Access Compliance Report

Public Rights-of-Way

(Curb Ramps)

Intersection ID: 44685	Main Street: HARWOOD_HILLS_LN	Cross Street: HARWOOD_LN	Location: W
ADA ID: 74F6F85A7020	Ramp Type: Perp	Initial Pass/Fail: Fail	Overall Compliance: No
Severity Score: 33.75			
Codes/Mitigation Info/Possible Solution		Field Measurements/Component Compliance

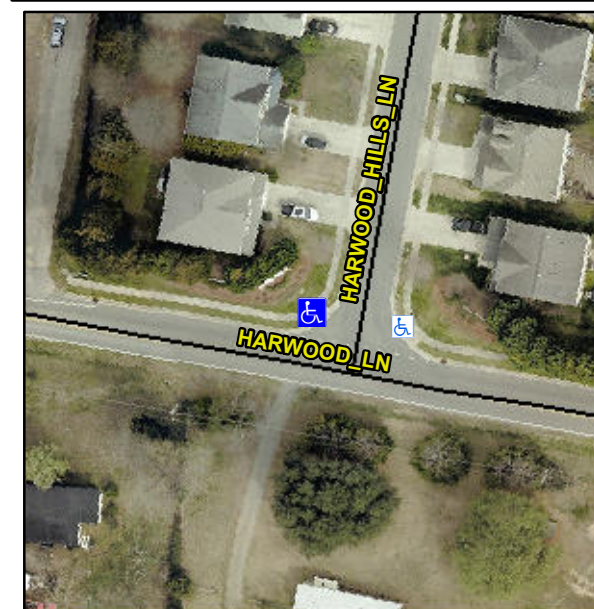
Not Found, R304.5.1, R304.2.2

Compliance	Description	Data	Compliance	Description	Data
N/A	Ramp Length (in)	49.0	No	Ramp Slope (%)	13.2
No	Ramp Width (in)	41.5	Yes	Ramp XSlope (%)	1.0
N/A	Flare Type LT	N/A	N/A	Flare Type RT	N/A
N/A	Flare Slope LT (%)	N/A	N/A	Flare Slope RT (%)	N/A
N/A	Flare Traversable LT?	N/A	N/A	Flare Traversable RT?	N/A
N/A	Landing Length (in)	N/A	N/A	DWS Provided?	N/A
N/A	Landing Width (in)	N/A	N/A	DWS Contrast?	N/A
N/A	Landing Slope (%)	N/A	N/A	DWS Length (in)	N/A
N/A	Landing X Slope (%)	N/A	N/A	DWS Full Width?	N/A
N/A	Landing Curb? (Y/N)	N/A	N/A	DWS Offset (in)	N/A
N/A	Shared Landing?	N/A			
N/A	Gutter Ponding?	N/A	N/A	Gutter Slope (%)	N/A
N/A	Gutter Lip Ht (in)	N/A	N/A	Gutter X Slope (%)	N/A
N/A	Painted X Walk1?	No	N/A	Painted X Walk2?	N/A
	X Walk 1 Direction	To E		X Walk 2 Direction	N/A
N/A	X Walk 1 Width (in)	N/A	N/A	X Walk 2 Width (in)	N/A
	X Walk 1 Slope (%)	4.0		X Walk 2 Slope (%)	N/A
	X Walk 1 X Slope (%)	1.4		X Walk 2 X Slope (%)	N/A

Remove & Replace Entire Ramp.
